OYSTER CREEK NUCLEAR GENERATING STATION, UNIT NO. 1

AMENDMENT TO PROVISIONAL OPERATING LICENSE

Amendment No. 15
License No. DPR-16

SAFETY EVALUATION BY THE OFFICE OF NUCLEAR REACTOR REGULATION

FIGURE 3.10.1

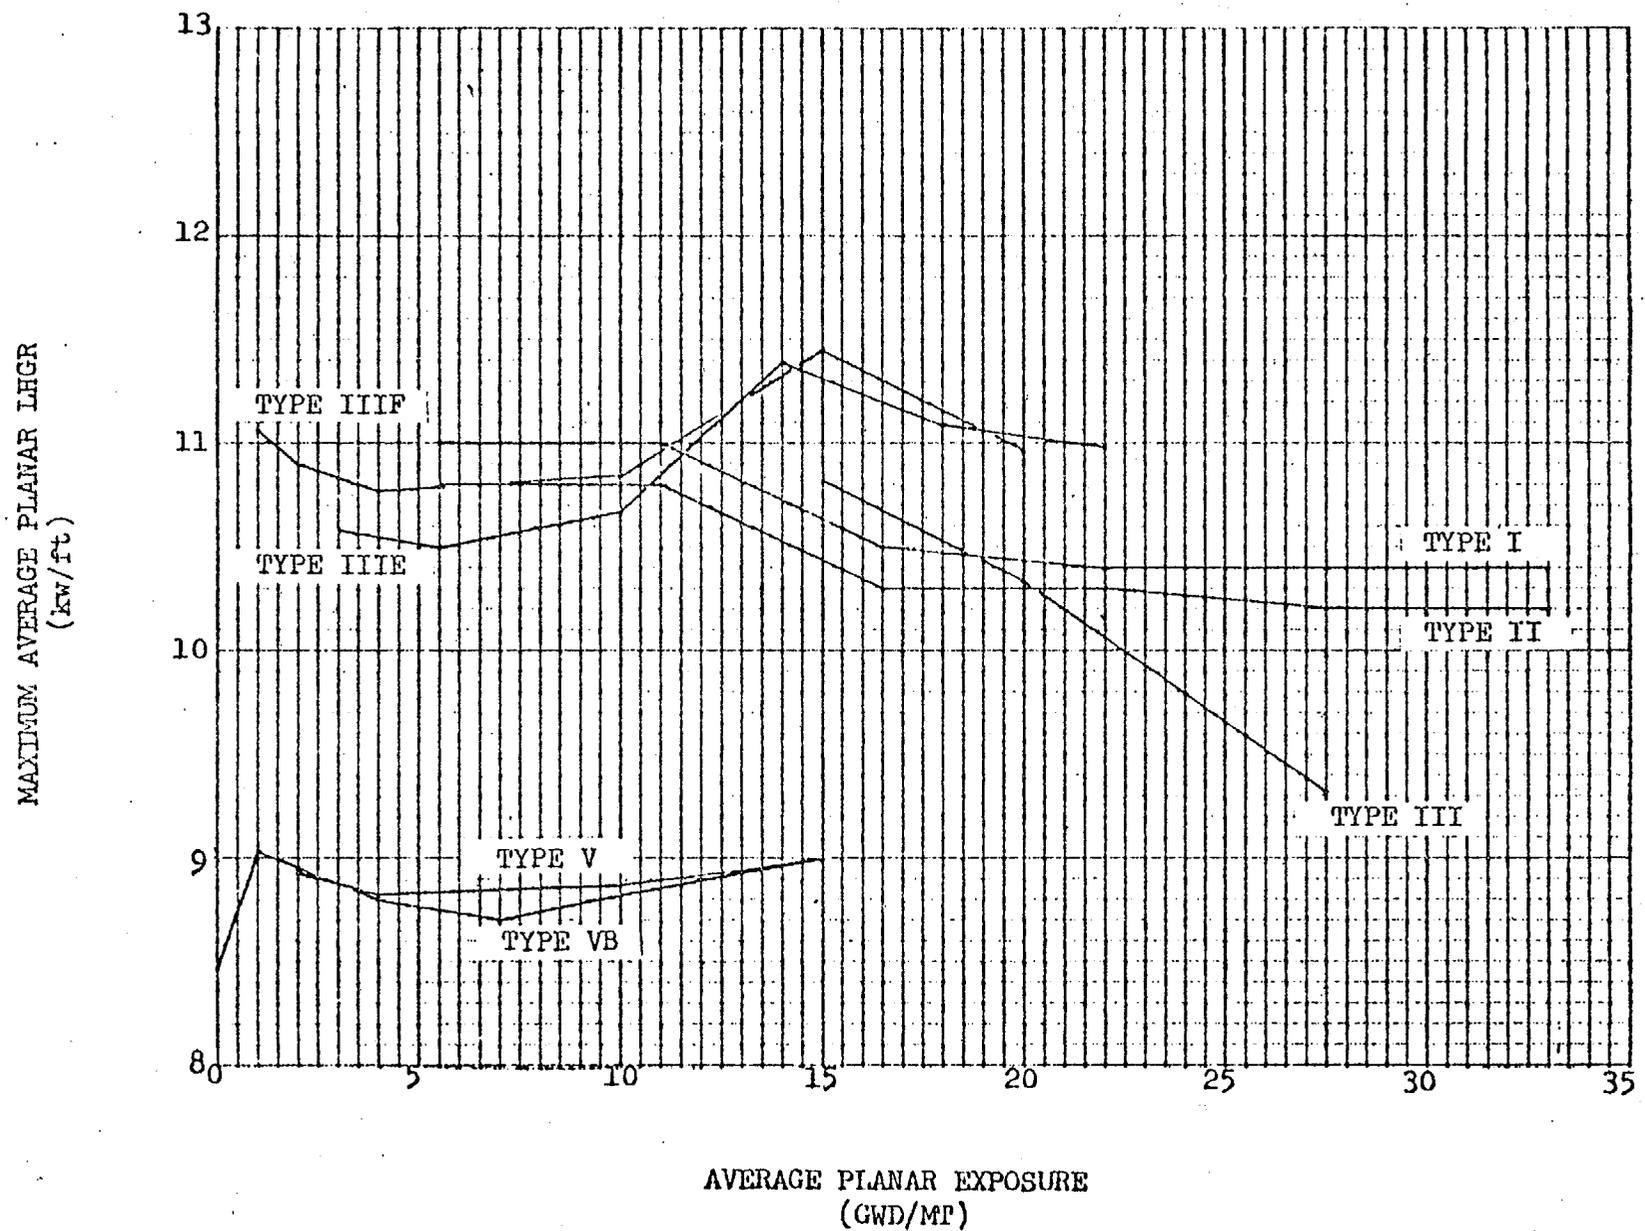
Replace pages 3.1-6a, 3.1-11, 3.1-12a, 3.3-2, 3.4-2, 3.4-5, 4.7-1, 4.7-2 and Figure 3.10.1 with the attached revised pages. Add pages 3.1-11a, 3.3-2a and 3.10-5.

The maximum average planar LHGR shown in Figure 3.10.1 for Type I and II fuel are the result of LOCA analyses performed utilizing a blowdown thermal-hydraulic analysis developed by General Electric Company in compliance with 10 CFR 50, Appendix K (January 4, 1974). Single failure considerations were based on the revised Oyster Creek Single Failure Analysis submitted to the Staff on July 15, 1975.

The maximum average planar LHGR shown in Figure 3.10.1 for Type III, IIIE, IIIF, V and VB fuel are the result of Appendix K approved LOCA analyses performed by Exxon Nuclear Company utilizing blowdown results obtained from General Electric Company which reflect revised single failure considerations. (1)

Analyses for the limiting 0.5 ft² break in a recirculation line with these single failure assumptions predict a peak cladding temperature of 2200°F, a local cladding oxidation of less than 16.9%, and a core wide metal water reaction of less than 0.85% when the core is operated in conformance with (1) the Maximum Average Planar Linear Heat Generation Rate (MAPLHGR) limits of Figure 3.10.1 of JCP&L's December 23, 1975 submittal, and (2) the power-void relationship ("B" values) stated in Section 3.10.C of the Oyster Creek Technical Specifications. It should be noted that the analysis considered various times in core life for the seven fuel types in the core. The above cited values do not all occur simultaneously.

It should also be noted that the present analysis assumes more severe single failures than the previous analysis, and the resulting MAPLHGR limits due to this change are about 1.0% lower than previously. However, for those cases at higher exposures where fuel and cladding failure was predicted in the previous analysis, Exxon Nuclear Company (ENC) has subsequently performed a more realistic but still conservative calculation which results in a more than compensating MAPLHGR limit increase. Instead of the design limit Linear Heat Generation Rate (LHGR) which ENC assumed previously to calculate fuel pellet gas release, they now have assumed values closer to (but still above) the actual maximum LHGR for each individual fuel rod. This results in a lower calculated internal gas pressure, a higher predicted rupture temperature, less rods predicted to rupture, and a lower calculated Peak Clad Temperature (PCT) for a given MAPLHGR (or conversely a higher allowable MAPLHGR at the limiting PCT). In their submittal dated February 5, 1976, JCP&L has supplied the results of several example calculations for different fuel types in the exposure range where this effect occurs, and has demonstrated to our satisfaction that this calculation method is realistic but still conservative, and represents no deviations from the approved ECCS model. Therefore, this approach and the resulting higher MAPLHGR limits are acceptable.
